RE: C-144 Conditions of Approval for a Below-grade Tank Permit

Facility or Well Name: LAWSON LS 001A - Tank B

API Number: 30-045-22513

**Pit, Closed-Loop System, Below-Grade Tank, or
Proposed Alternative Method Permit or Closure Plan Application**

GROUNDWATER LESS THAN 50 FT.

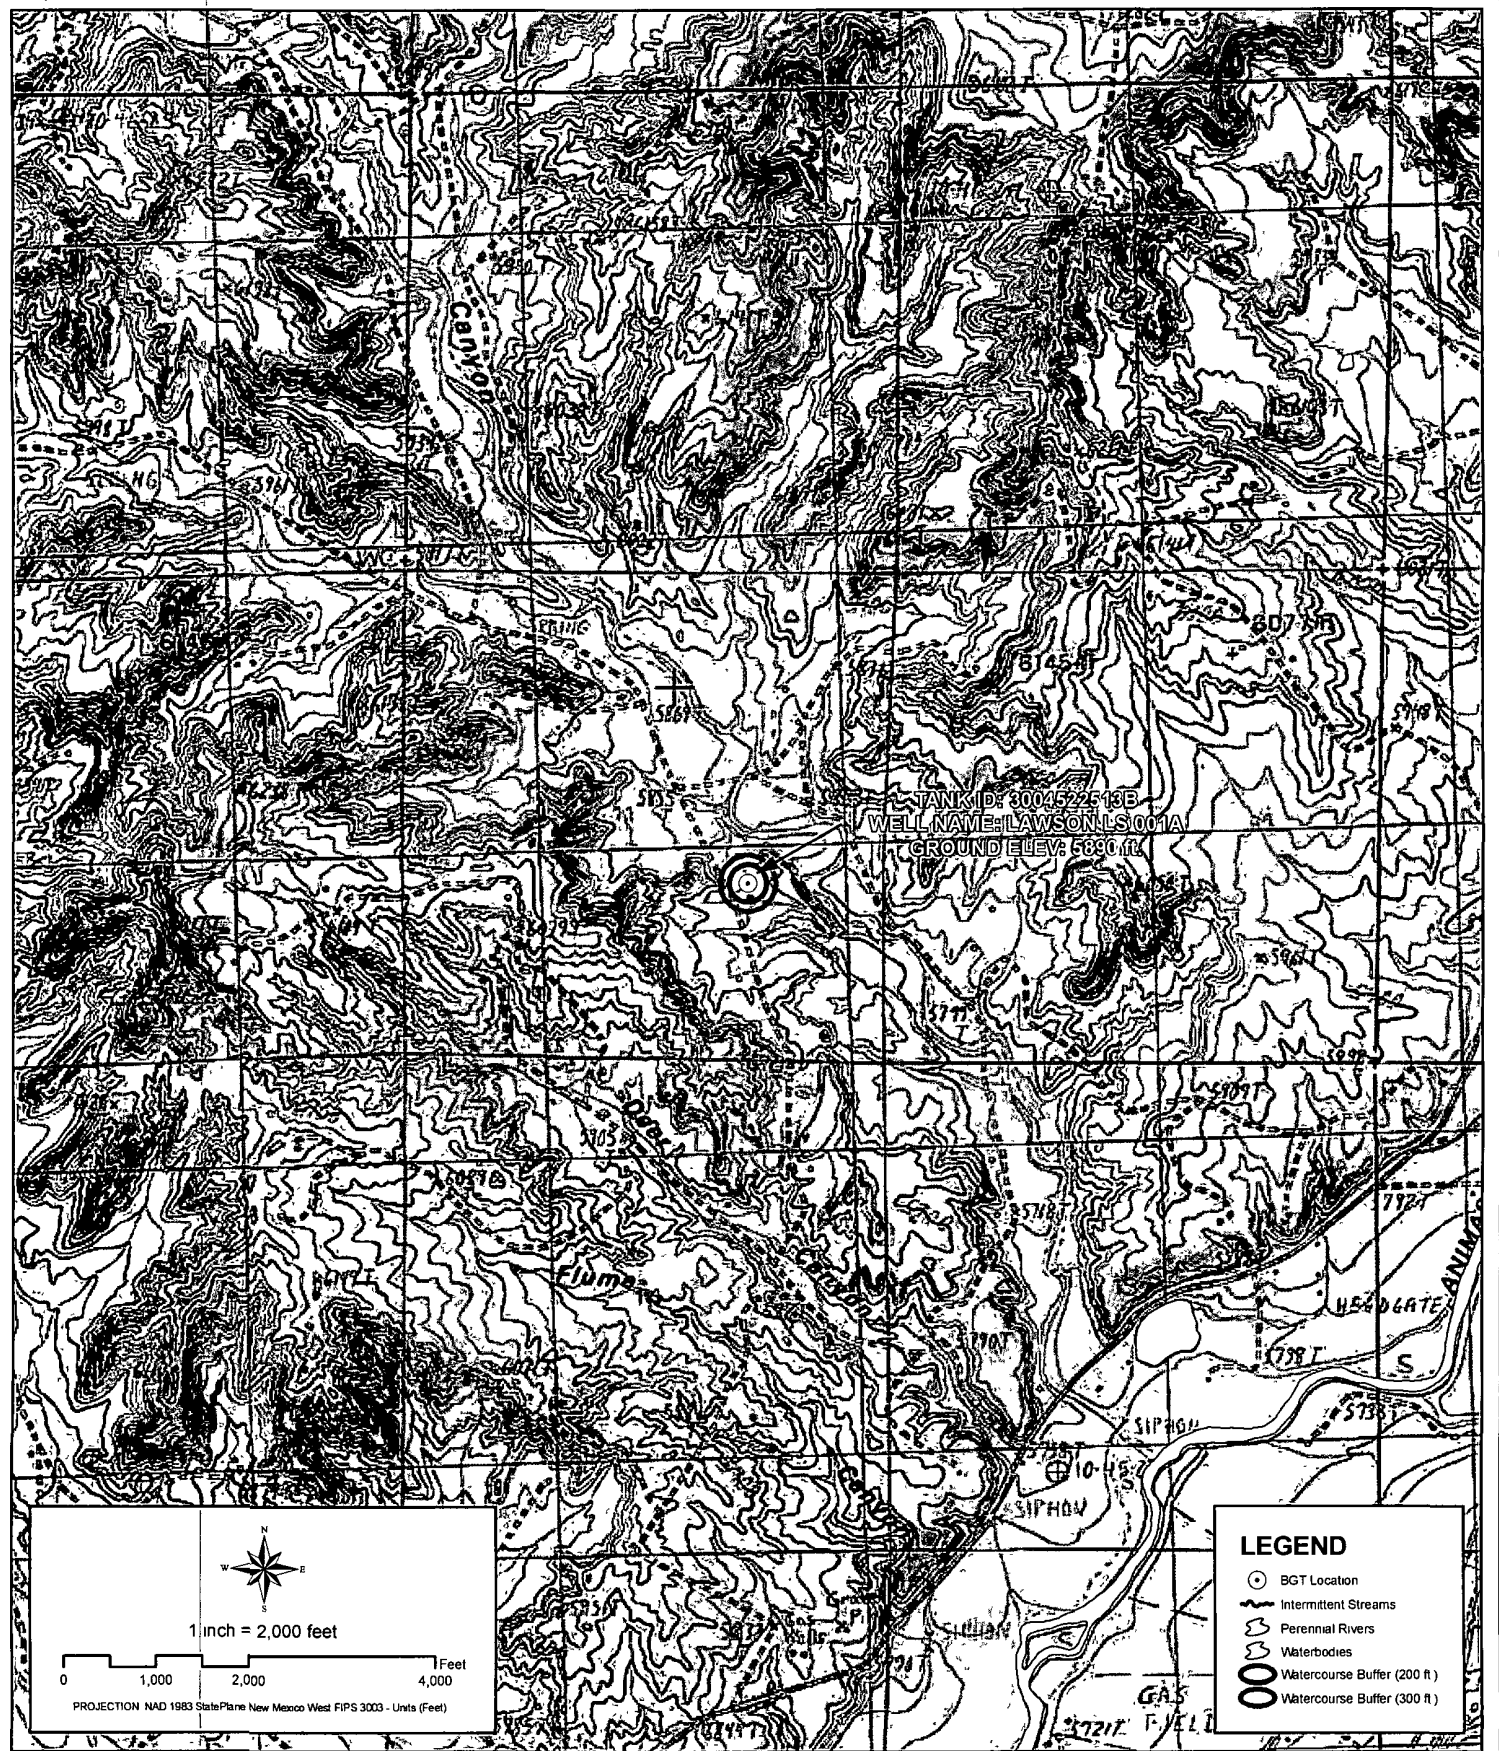
The Oil Conservation Division (OCD) has reviewed BP America Production Company's (BP) application, dated June 9, 2010, to permit an existing below-grade tank pursuant to 19.15.17 NMAC. BP provided information in the application packet which revealed issues with the operation of the current design in regards to the conditions at the proposed location. The application revealed issues of concern regarding the separation to ground water beneath the existing below-grade tank. A review of the supporting documentation for the assessment of the local hydrology revealed that the depth to ground water not between 50 and 100 feet, but was less than 20 feet below the ground surface.

The OCD considers the continued operation of the existing below-grade tank's design, combined with the identified siting issue is an imminent danger to fresh water, public health and the

Based upon the information provided in the permit application packet, OCD hereby approves only the closure of the existing below-grade tank identified above with the following condition:

- BP shall complete the closure of the below-grade tank pursuant to the approved closure plan within one calendar year of this approval, by March 22, 2012.
